Permit Type	Permit Number	Opened Date
Building/Residential/Misc/Shed	B26000150	01/16/2026
Description of Work		
SFD/ CONSTRUCT 20' X 32' POLE BARN FOR STORAGE

APPLICATION FOR WAIVER

SITE INSPECTION SHEET

From: Eshenbaugh, Melanie
Sent: Friday, January 30, 2026 5:12 PM
To: 'JACKANDBERN@GMAIL.COM'
Subject: B26000150
Attachments: BuildingPermitApplicationProcessWellSeptic 7-2024.pdf

SITE PLAN

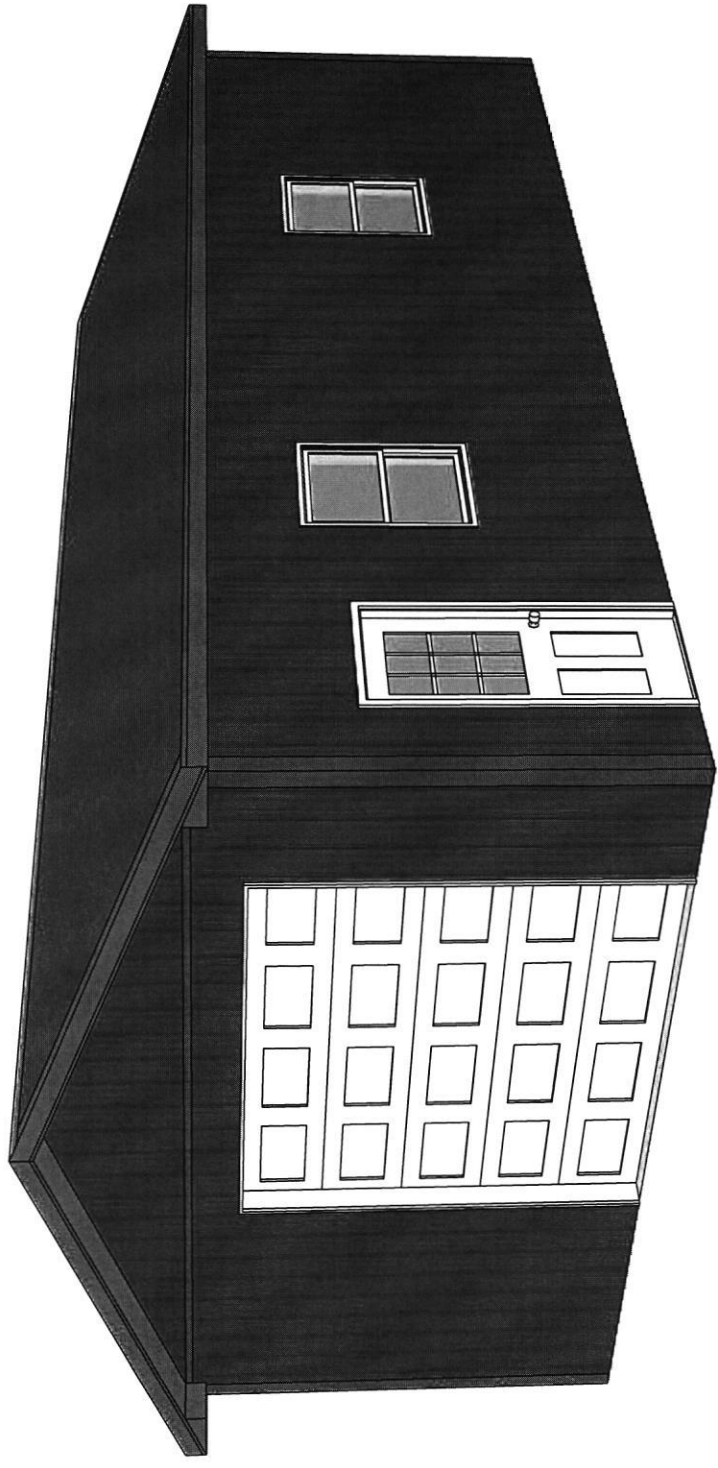
Plans have been submitted to build a 20x32' shed. The proposed shed will be built on the lower, southwest side of the yard, approximately 13' off of the property line. The shed will sit between 11'-16' back from the swale.

Sec. 3.805. - PERC certification plan requirements. We are requesting a waiver from providing a plan for a sewage disposal area (SDA) established for future septic repair. We understand Code requires establishment of an SDA per two replacement systems; however, this shed will be located in an area where an SDA would not be suitable. Along with the waiver from the SDA plan, we are requesting a waiver from the percolation test. As we would not be putting the shed in an area that is suitable for septic, the perc test does not apply.

Our proposed shed site will be less than 25' from the existing swale. A septic tank and drainage field cannot be located at this site, as it would run in the same area as the swale. Therefore, the site plan and perc tests are unnecessary as this shed area would be excluded from a potential future septic site.

approved in location shown on plan.
[Signature] 2/19/26

SITE PLAN

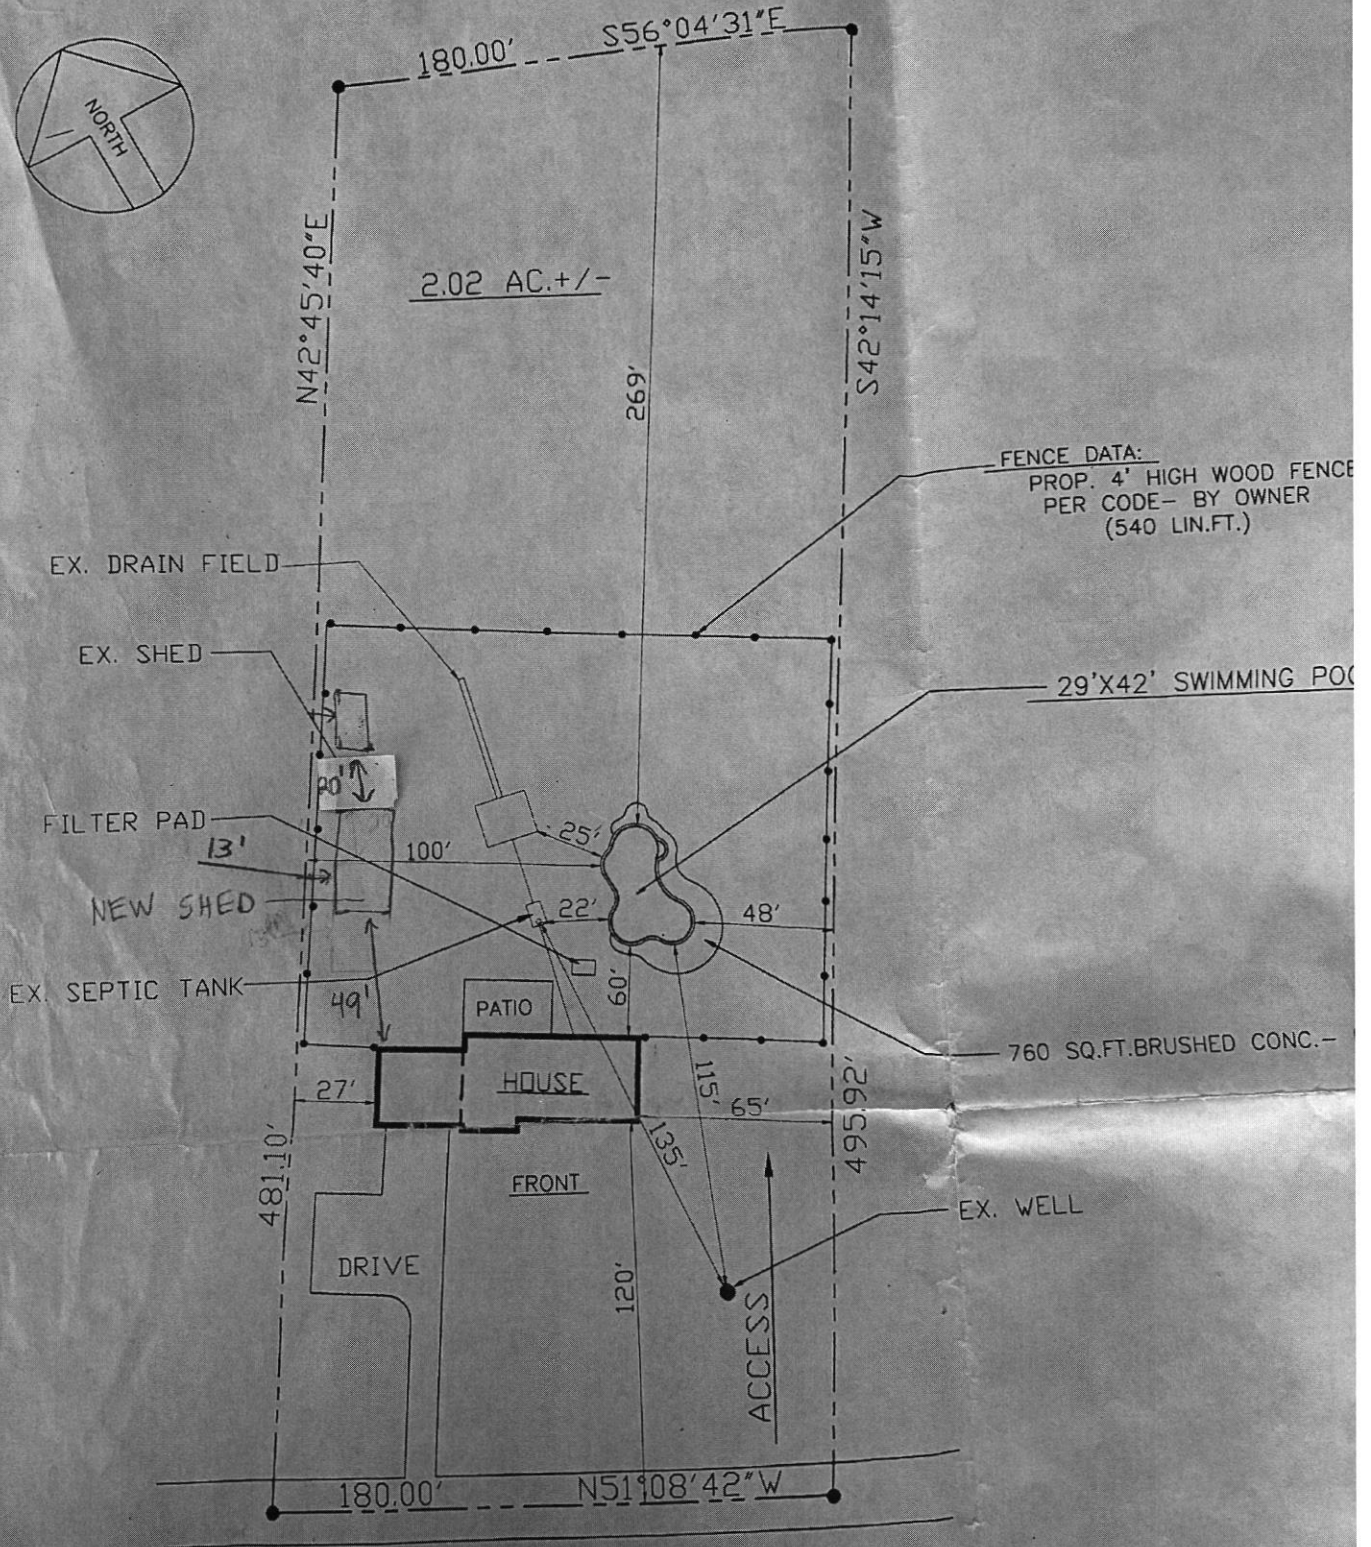
SETBACKS:

REAR PL.	10'
SIDE PL.	30'
HOUSE	0
SEPTIC	20'
WELL	30'

NOTE: A VACUUM BREAKER
WILL BE INSTALLED
ON JOB AS PER
CODE.
